PART 21 - BARTON MODEL 288A AND 289A DIFFERENTIAL PRESSURE SWITCH DEFECT

PRODUCT ADVISORY

Model 288A and 289A Differential Pressure Switch Defect

DOCUMENT NO.: 210036966.01

MODEL 288A/289A SWITCH OPERATING MECHANISM MOCKUP

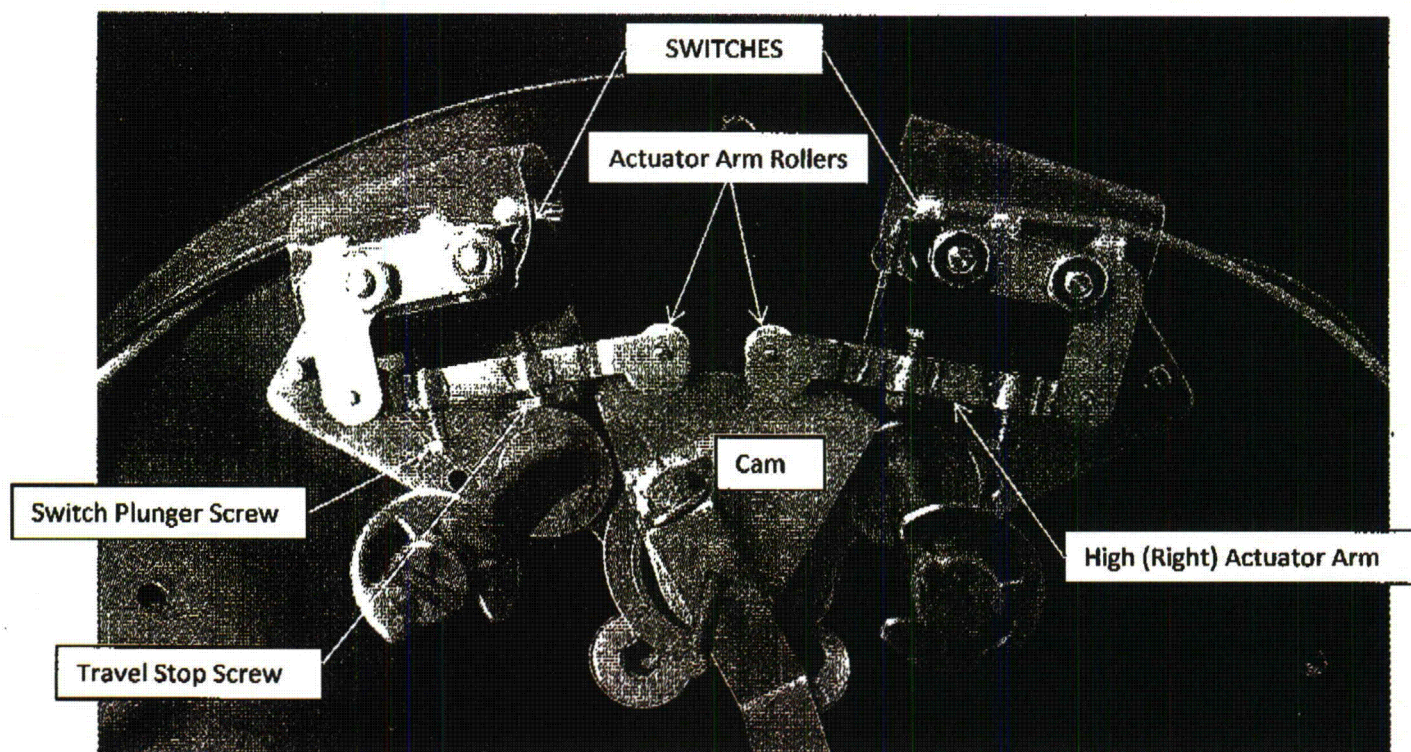
During the investigation of an apparent setpoint drift issue on Model 289A Indicating Switches at an operating nuclear power plant, Cameron uncovered an out-of-specification concentricity issue with the switch actuator roller that rides on the switch operating cam. No other utilities have reported a similar issue.

With the nonconforming rollers, a switch can still operate within the repeatability specification of 0.25% as long as the roller radial position remains the same when at the switch trip position. However, if the radial position of the roller changes (due to vibration, multiple fluctuations in the sensed differential pressure that causes the roller to move off and on the cam high point, etc.) then the switch can trip at a different value. Based on a sample of approximately 100 rollers inspected, a maximum repeatability error in the neighborhood of 2% has been observed. It is expected that the tolerance would be cyclical if the roller moves to new positions, with both increasing and decreasing values recorded over time.

We are currently in the process of procuring conforming parts and anticipate the ability to repair instruments in the near future. This repair will necessitate factory activity to remove and replace the out of specification roller, recalibrate the instruments and subject them to the customer defined cleaning process before they can be returned.

Due to the nature of this concentricity issue, it warrants immediate notification so that appropriate utility evaluation and remedial action can be implemented. Until such time that final reviews of the above utility identified setpoint drift concern are completed, Cameron recommends that utilities perform increased switch setpoint verifications especially where historical records indicate repeatability issues.
